Access Compliance Report

Public Rights-of-Way

(Curb Ramps)

Intersection ID: 30292	Main Street: DERRYFIELD_DR	Cross Street: NIGEL_CT	Location:	E
ADA ID: C8F66C067619	Ramp Type: BlendTrans1	Initial Pass/Fail: Pass	Overall Compliance: No	Severity Score: 15
Codes/Mitigation Info/Possible Solution		Field Measurements/Component Compliance

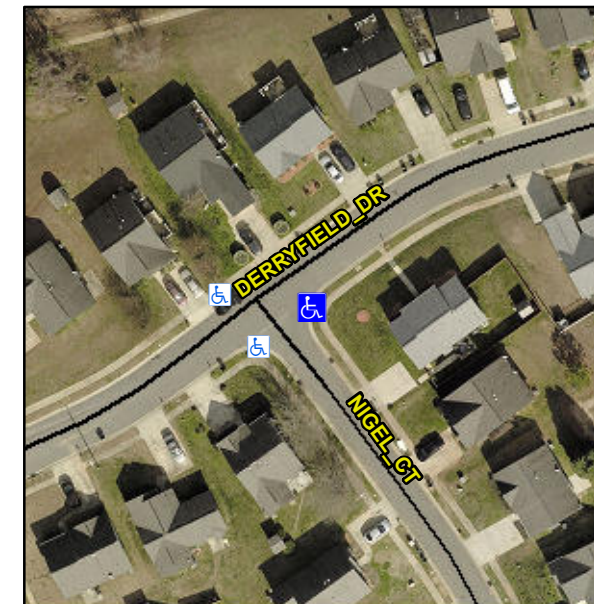
CURB WIDTH 46.0

Not Found, R304.2.1, R304.5.3, R305.1.4, R305.2, R302.7.2, R304.5.4

Remove & Replace Curb Ramp With Two New Directional Ramps or Equivalent. Remove & Replace Gutter.
